From: Robert Kuhfuss [REDACTED]
Sent: Thursday, February 12, 2026 7:24 AM
To: Chris Jacques <chris.jacques@peoriaaz.gov>
Cc: LuAnn Kuhfuss [REDACTED]
Subject: Kuhfuss comments re PIC

RE: Peoria Innovation Core – Edge Treatment, Parcel 1-P

Edge Treatment – Parcel 1P

**CORE 1,
PARCEL 1P**

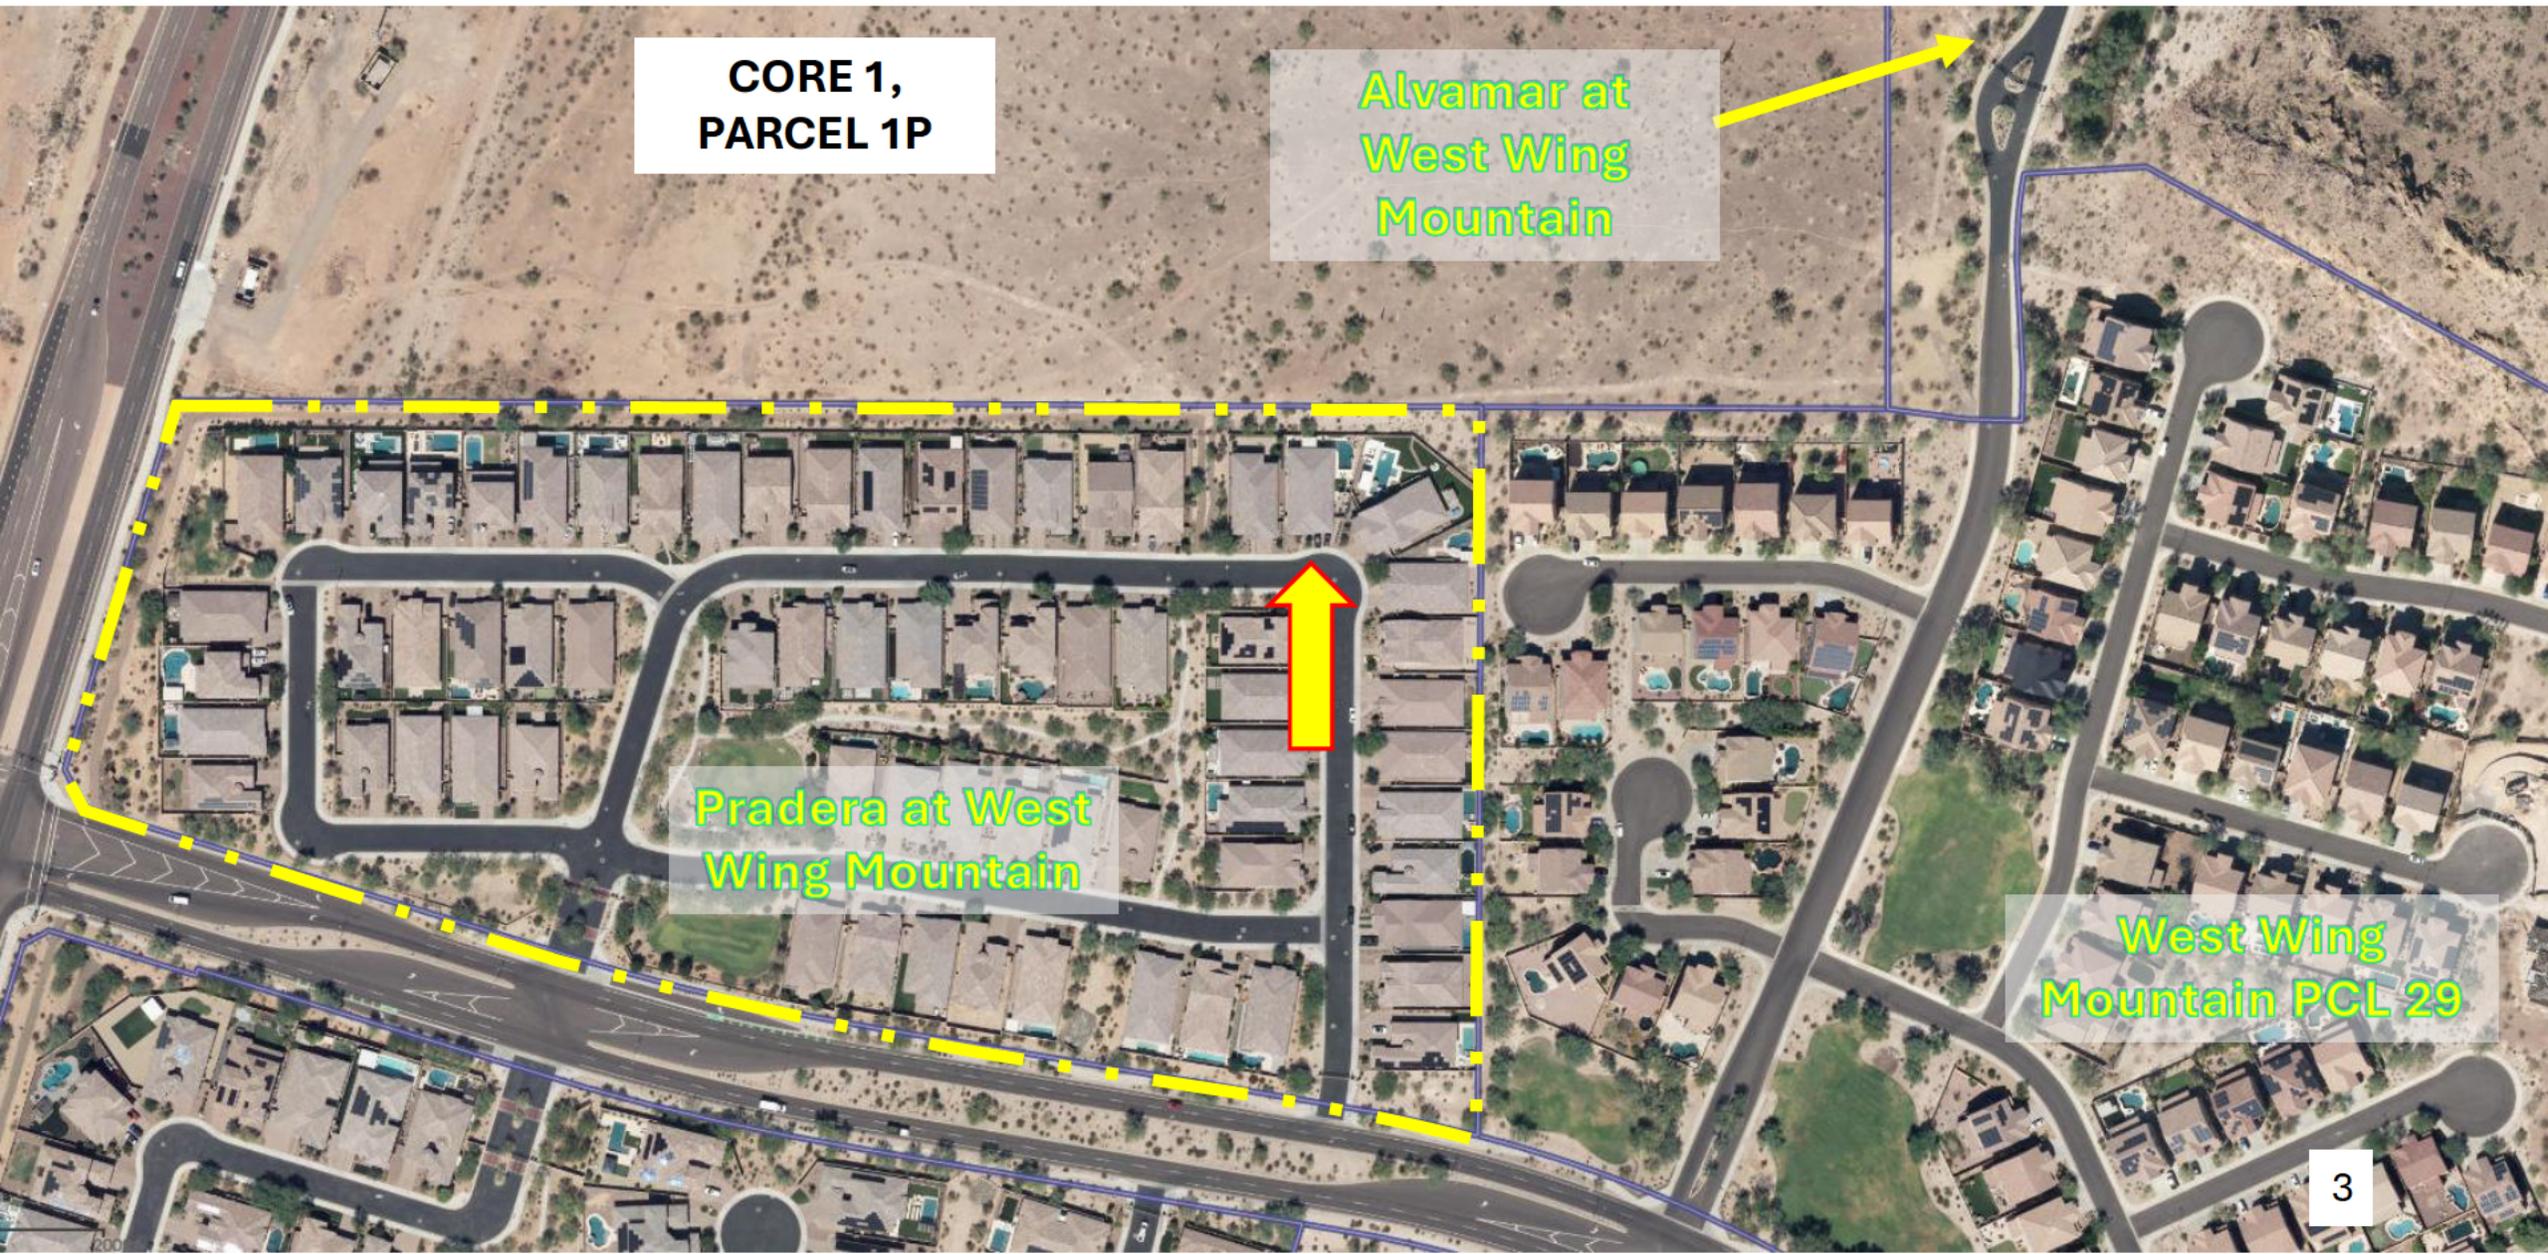
Thank you for the opportunity to provide my insights into the proposed zoning for the Peoria Innovation Core (PIC). My wife and I have been residents of Pradera at West Wing Mountain since 2018. Our property is located exactly 30 feet from the southern boundary of Parcel 1P of the proposed PIC Planned Community Development (PCD), as shown in Slides 2 and 3 of the attached PowerPoint.

30-FOOT LANDSCAPE BUFFER

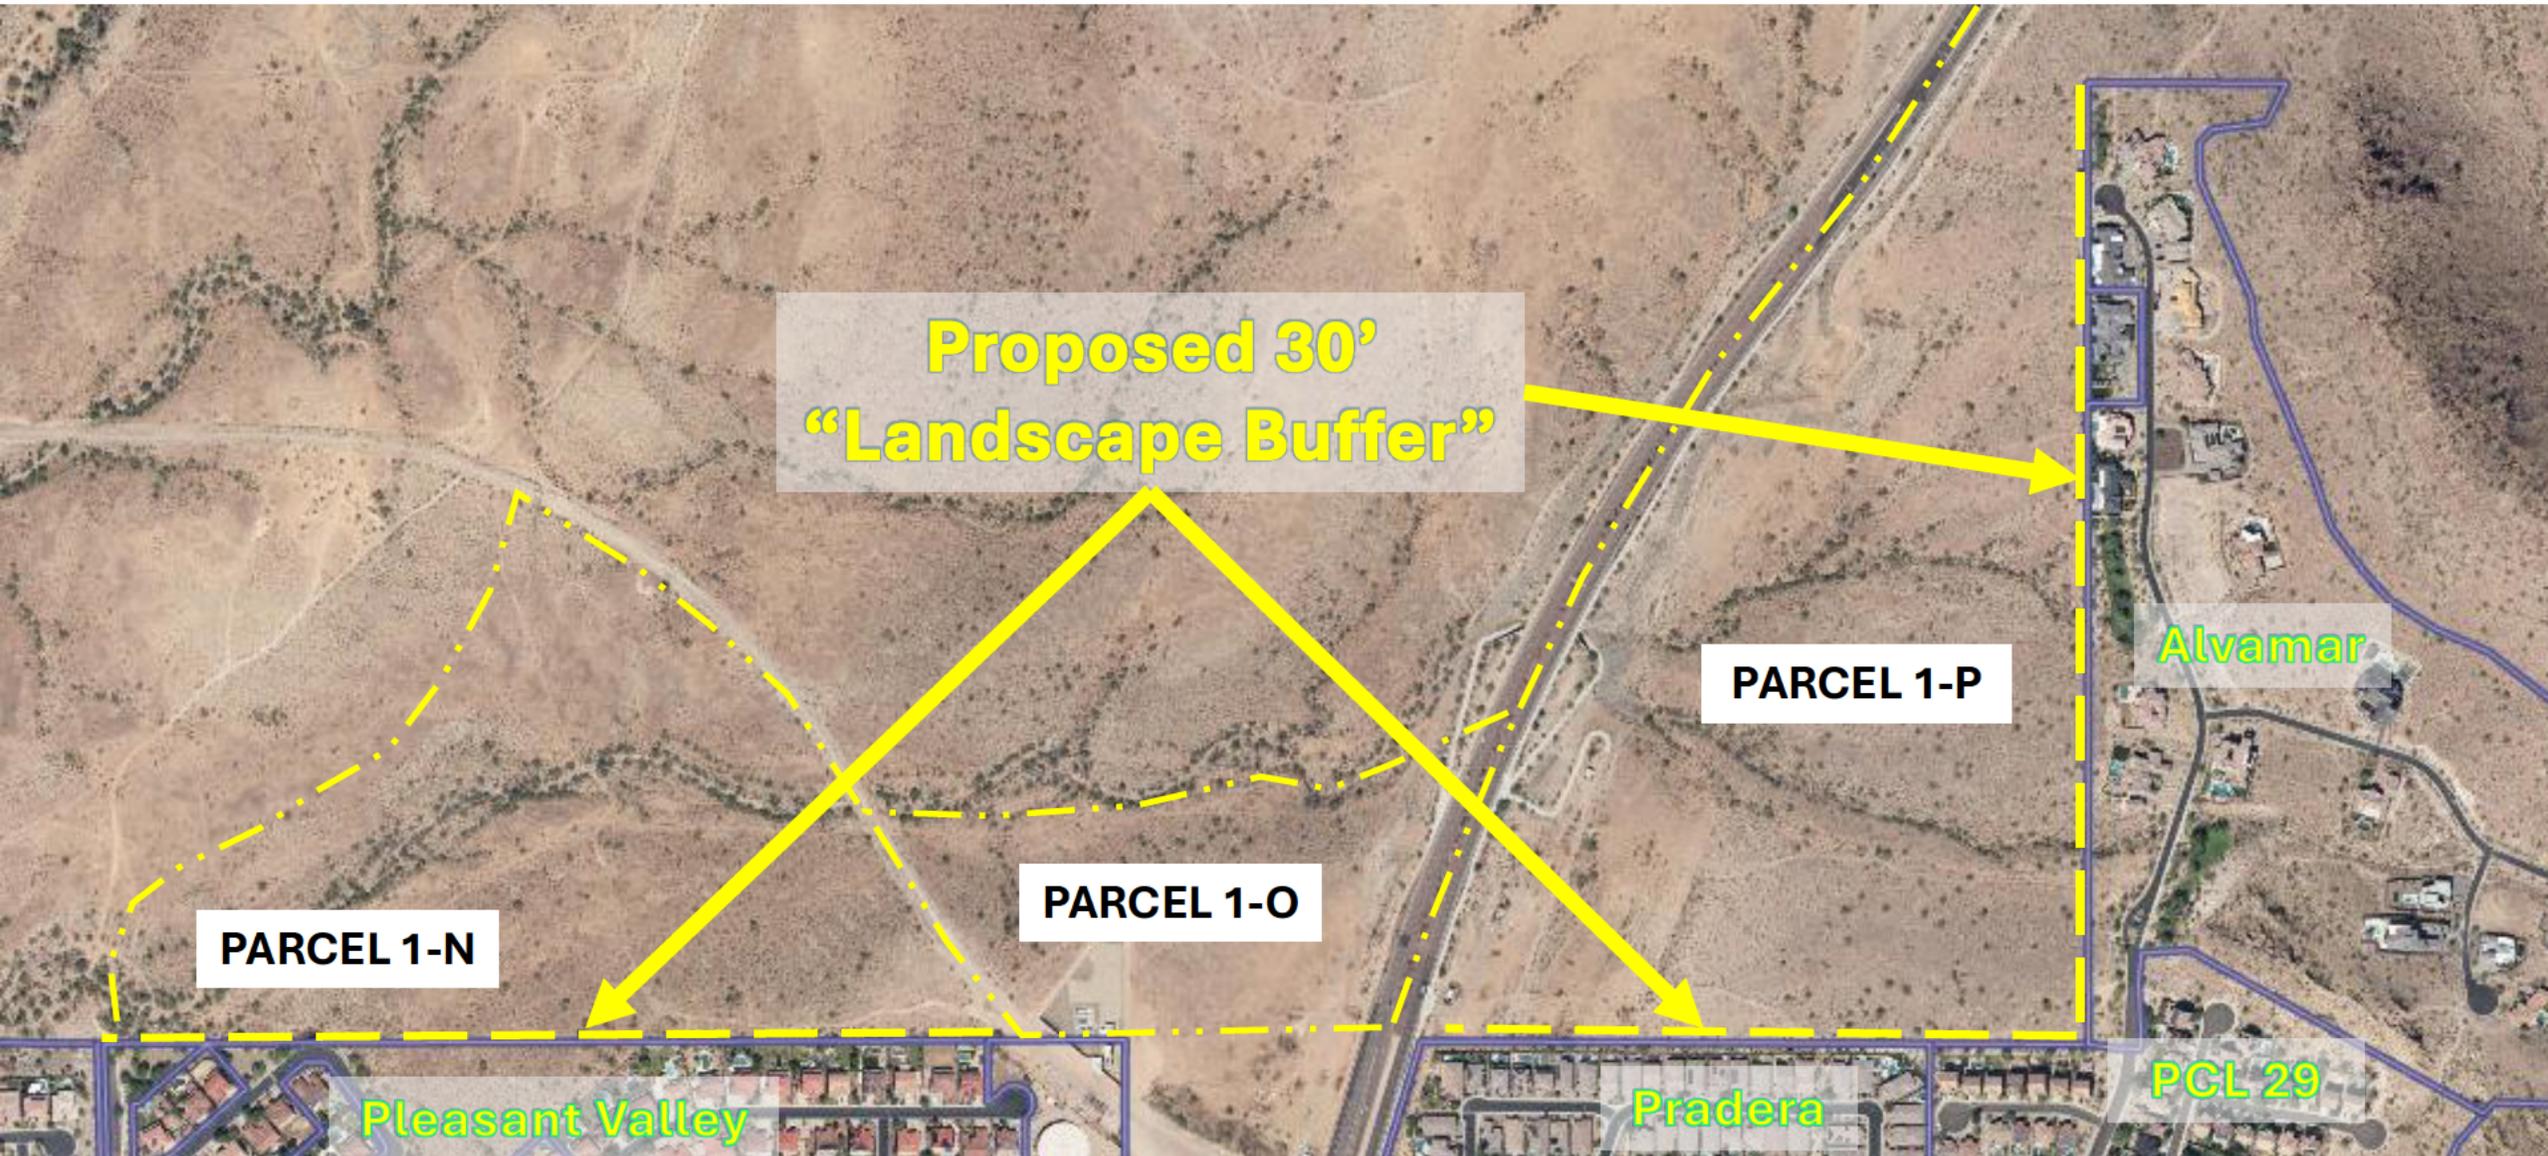
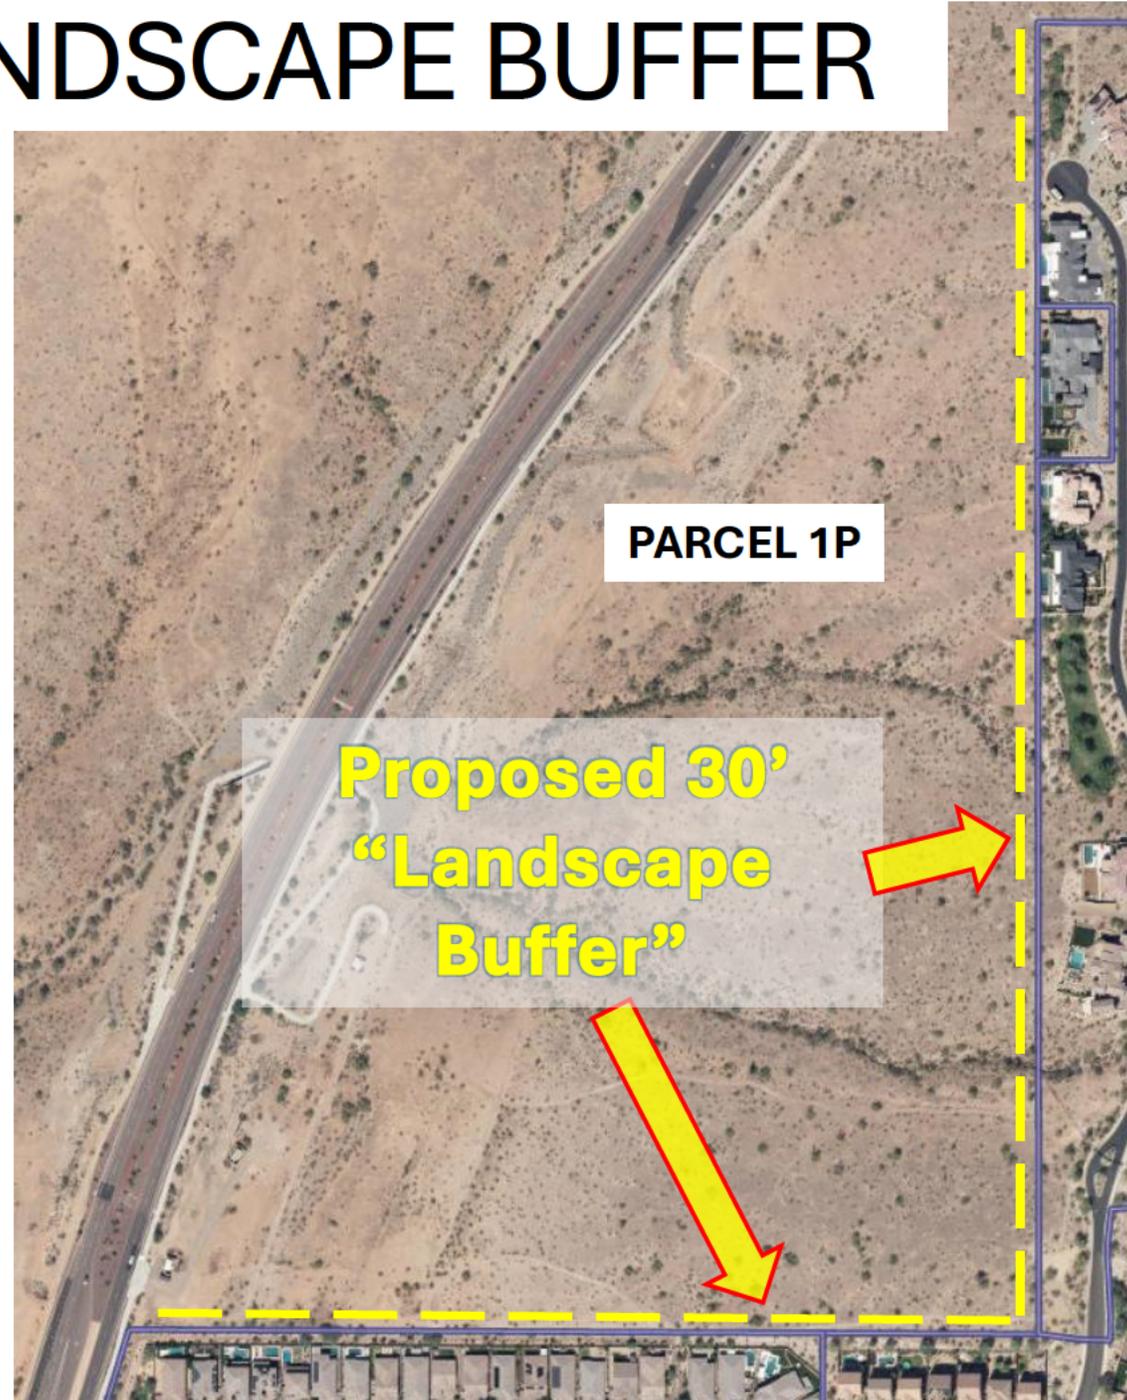
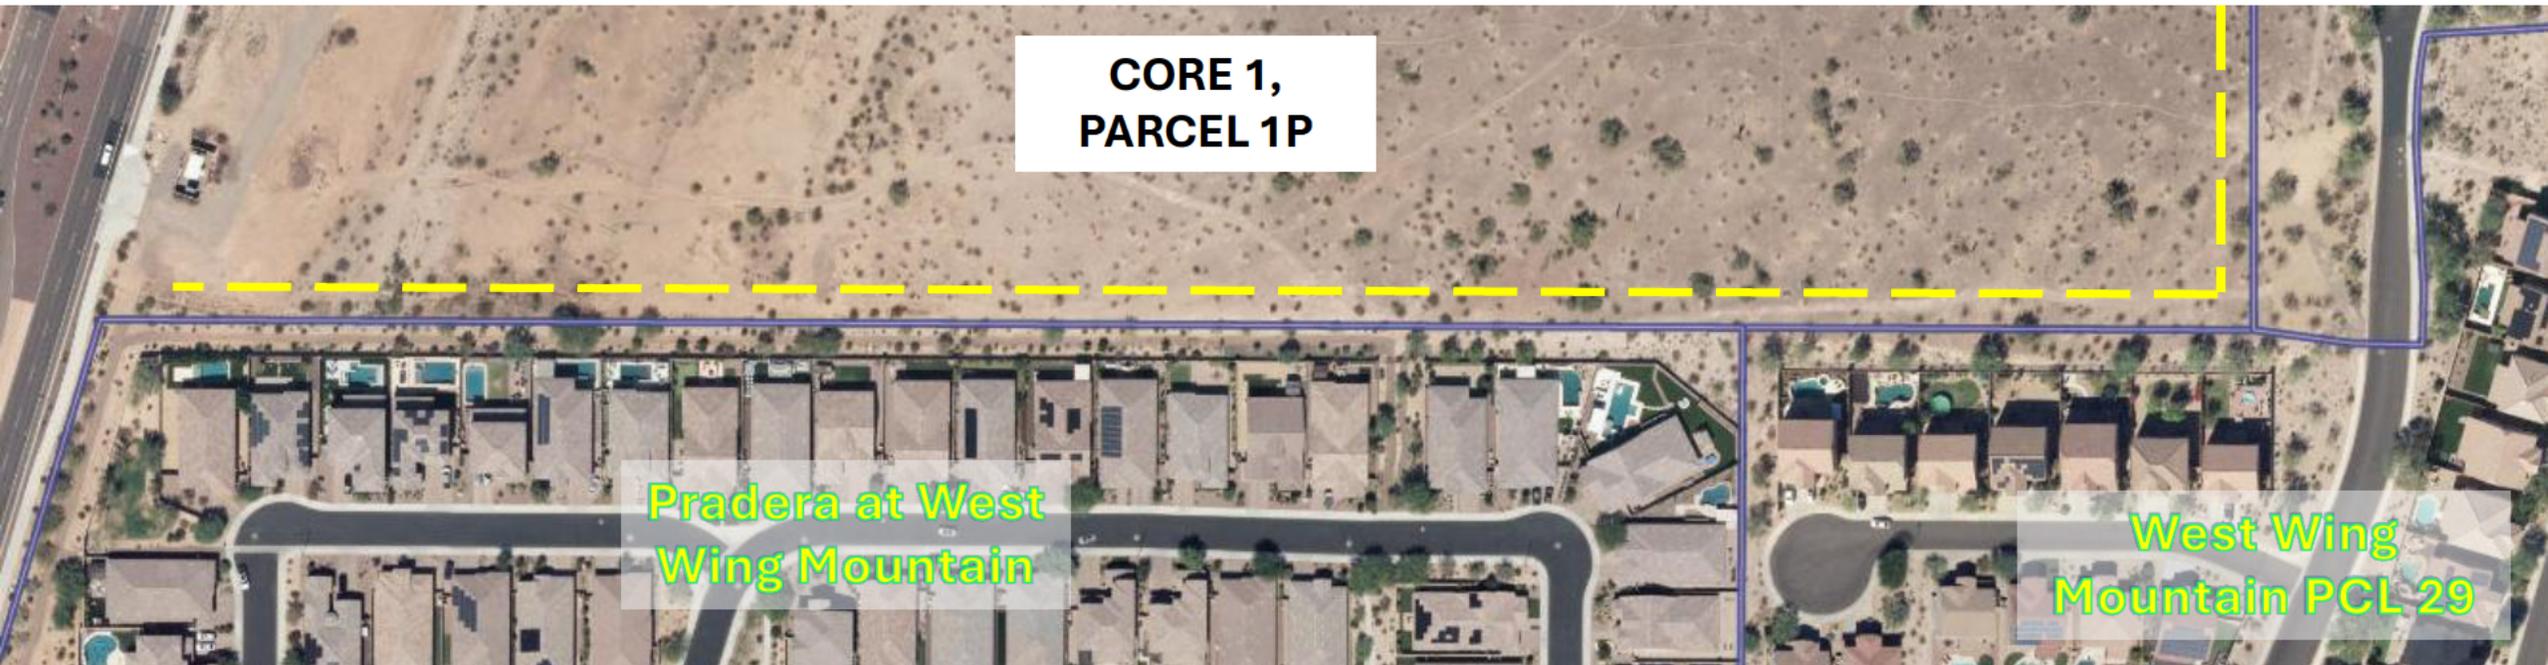
The aforementioned 30-foot landscape buffer is depicted on Slides 4 through 6. Slide 4 depicts the buffer extending along Parcels 1N, 1O, and 1P, while Slide 5 focuses on Parcel 1P. Slide 6 illustrates the condition as it relates to the south side of Parcel 1P and adjacent to the Pradera subdivision.

UNDESIRABLE EDGE CONDITION

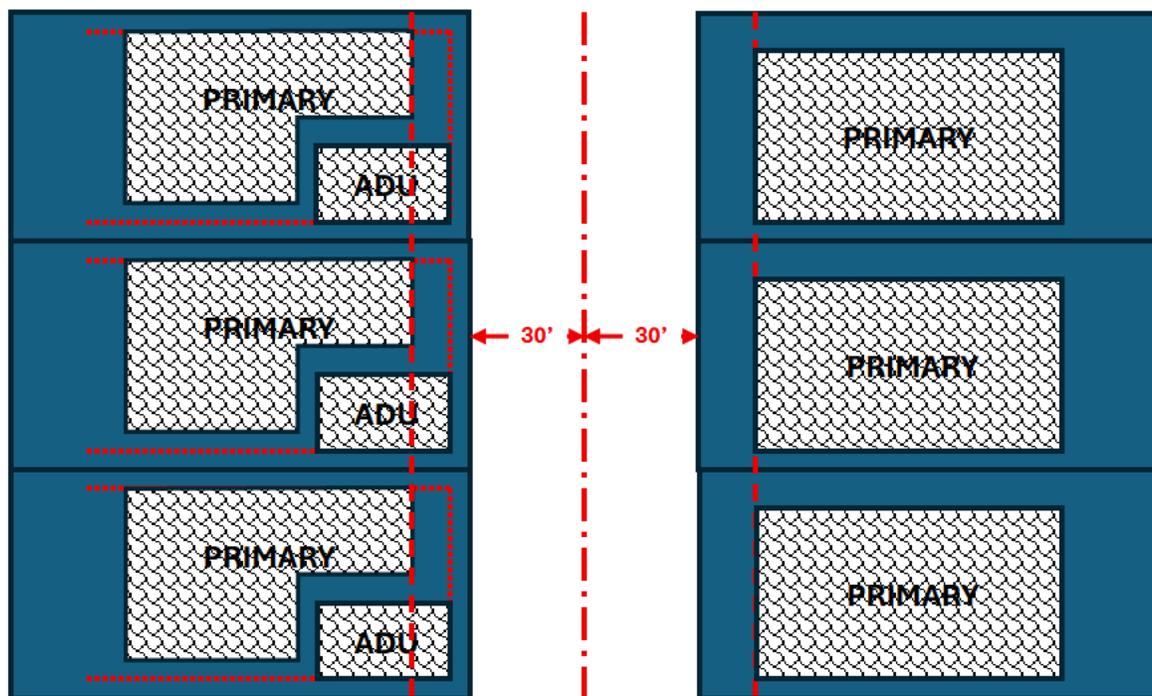
As noted, our fear is this will create an unsightly condition adjacent to our residence. Slide 7 depicts such a condition as it currently exists in another development in the area where it is dominated by an expanse of gravel, devoid of any natural beauty, and flanked by a 30-foot-high wall of stucco buildings. This condition can be mitigated by implementing three simple changes to the PCD documents:

- Increase the width of the Parcel 1P Landscape Buffer from 30 feet to 60 feet
- Place a 20-foot height limitation for all buildings located within 180 feet of the common boundary between Parcel 1P and the Pradera subdivision
- Replace the term “Landscape Buffer” with the term “Natural Open Space Buffer”
- Include a provision that negates a wall or fence along the southern boundary of Parcel 1p

EDGE CONDITION AS PROPOSED BY PCD

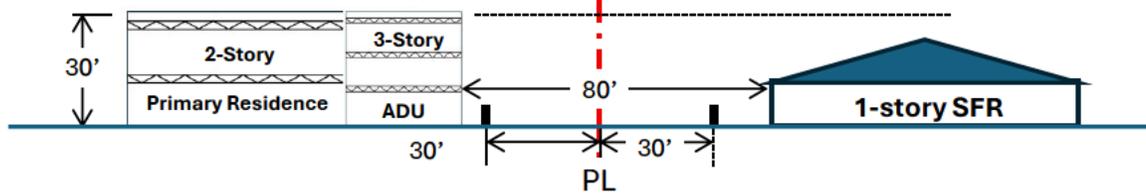
To further illustrate, Slide 8 illustrates a hypothetical condition that would exist for much of the south side of Parcel 1P under the currently proposed language of the PCD. This slide suggests three existing single-story residents set 15 feet from the rear lot line. Opposite those lots are three new two-story residents, each with an Accessory Dwelling Unit, with architecture assumed to be contemporary, similar to that depicted in Slide 9. Between the two rows of lots is an existing 30-foot drainage / open space tract as well as a 30-foot landscape buffer per the PCD. Note that under state statute, the property owner would be entitled to a two-story ADU, while under the current language of the PCD, the ADU could be as many as three stories in height as long as it does not exceed 30 feet. This configuration would create an imposing condition along the common boundary.

- ❖ Right side denotes existing condition along north side of Pradera Subdivision.
- ❖ Left side denotes potential 1P condition as currently proposed in PCD documents.
 - ❖ 30' Landscape Buffer
 - ❖ 30' Building Height
 - 30' High Primary Residence
 - 30' High Accessory Dwelling Unit

Height restrictions, as currently stated in the PCD, only limit the overall height of the building. They do not limit the number of stories. This could result in a 3-story, flat roof design for both the Primary and Accessory Dwelling Units.
